Product Change Notification

Change Notification #: 117389 - 00
Change Title: Intel® Server System R2208WFQZSR, PCN 117389-00, Product Design, Label, 1300W PSU Temperature Sensor relocation, BIOS/ME/BMC Firmware Update
Date of Publication: January 10, 2020

Figure 1. Old PSU label

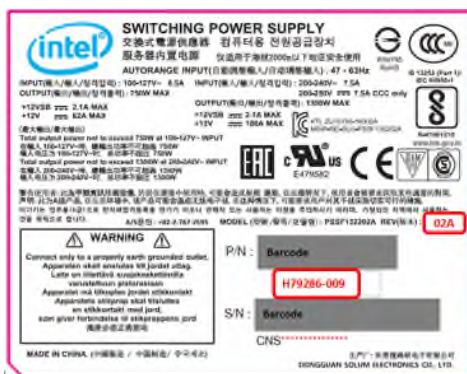
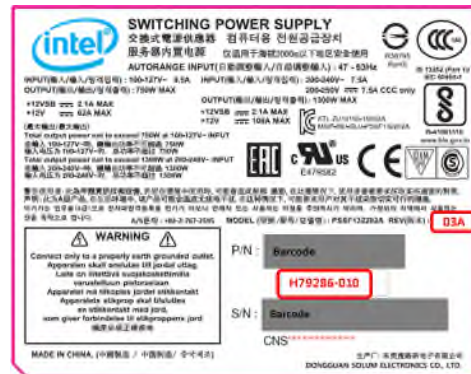
- Changes to the 1300W Power Supply Unit (PSU)
 - PSU temperature sensor is moved away from pre-heated air to improve the accuracy of the PSU temperature measurement.
 - PSU firmware has been upgraded from 24.5.128 to 25.5.128 to support the new sensor location.
 - PSU product number is changing from H79286-009 to H79286-010 and revision number from 02A to 03A.
